# Lloyd's Register of Shipping.

undersigned Surveyor to this Society did at the request of Owners Representative, Survey the Steel Screw Motor Tanker "D I N A" of Willemstad 6341 Gross Registered Tons, for the purpose of (1) ascertaining the nature and extent of damage which stated to have been caused by shells and torpedoes during enemy action in November 1942, while the vessel was on a voyage from Fremantle to Overseas Port, and (2) recommending necessary repairs. It is stated that, after the action, the vessel returned to Fremantle under her own power. Further particulars see Log Books.

M.T. "ONDINA" AT FREMANTLE 14th JUNE 1943.

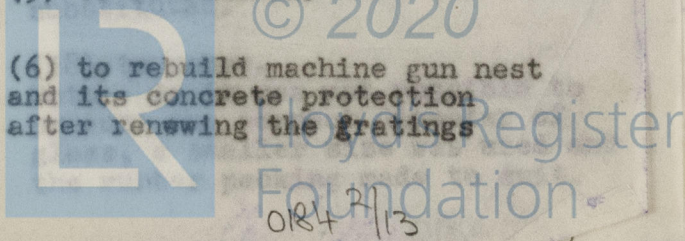
finder loop and  
ged beyond repair.

(4) a new loop and standard to  
be fitted.

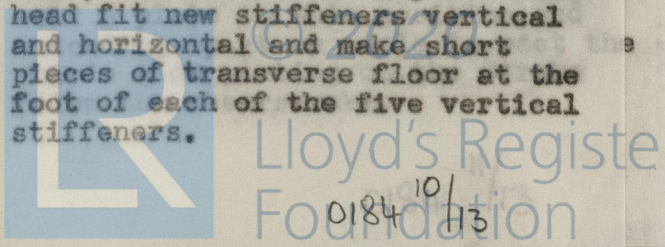
dinal bulkhead between  
and Starboard Tanks  
sing for its full  
en the vertical twin  
hing to the forward  
ulkheads and a posi-  
t to the forward web  
No.2 Starboard. The  
er stringers were  
from this position.  
forward web stiffener  
was bulged to Star-  
lly over a large area  
within three feet of  
anverse bulkhead.  
he after web stiffen-  
ly buckled as well as  
taching the starboard  
after deep transverse  
heating coils in the  
e of No.2 Centre Tank  
.as well as the Fuel  
Pipes. Numerous loose  
ets in addition to  
sly mentioned.

(71) that prior to fitting the  
wooden watertight wall in No.2  
Starboard Tank, the upper half  
of the longitudinal bulkhead be  
renewed, and after fitting the wall  
and pumping No.2 Centre Tank dry,  
this bulkhead be entirely renewed  
together with all necessary vert-  
ical and horizontal stiffeners  
and prepare same for attachments  
for lower struts. See drawing  
No. 1A W.G.D. "ONDINA" which will  
save much description. All loose  
rivets to be removed and grummet-  
ed bolts fitted and to be covered  
with cement as stated in Item 69.
